**STAFF REPORT:** 08-12-2020 MEETING

**APPLICATION NUMBER:** 20-6791

**ADDRESS:** 869 LONGFELLOW

**SCOPE:** REPLACE 10 WOOD 1/1 DOUBLE-HUNG WINDOWS WITH PELLA ARCHITECT SERIES 1/1 DOUBLE-HUNG WINDOWS

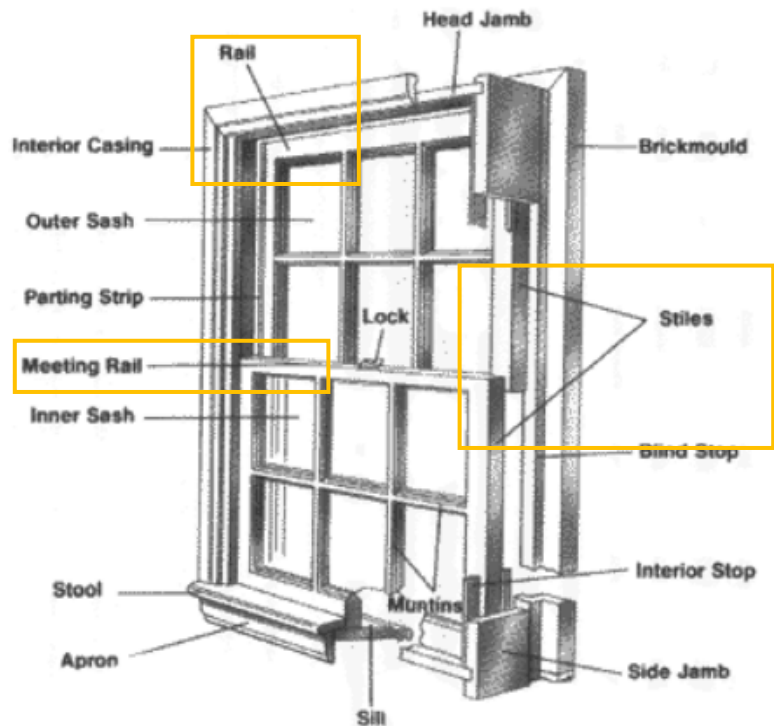
Reduction of glass width in replacement window:

1 inch = 3.44% decrease

Reduction of glass height in replacement window:

2 inches = 3.25% decrease

- While the dimensions of the existing and replacement sash were not submitted, the rough calculations based on the existing and proposed glass surface shows the physical alteration will be minimal.

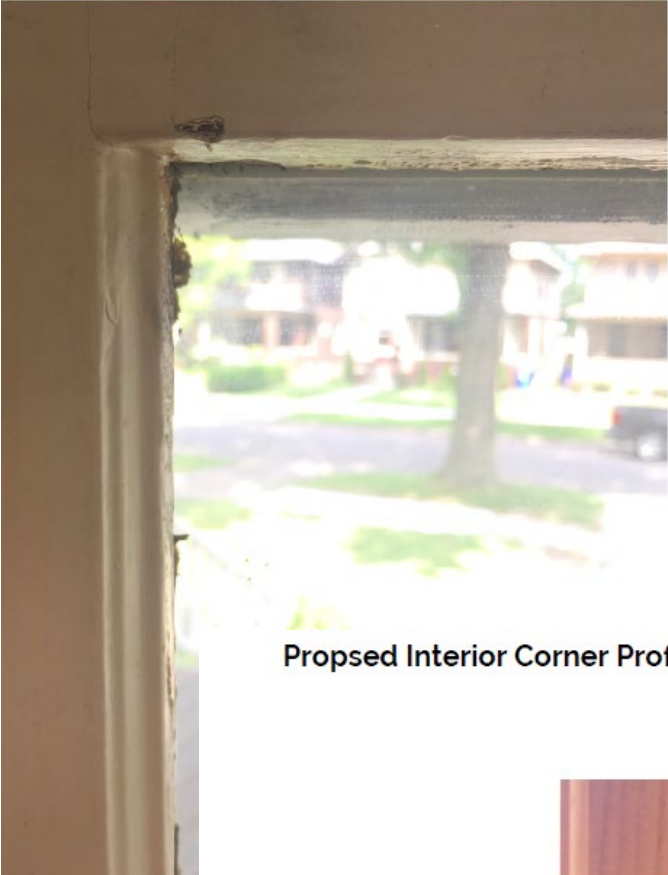
In addition to determining the change in glass area, staff asked the applicant to submit visual comparisons of the existing and proposed sash profiles. Staff compiled the photos on the following page.

- The visual comparison of the sash profiles of the existing and new window sash are very similar, and in staff's opinion they don't have a noticeable difference.
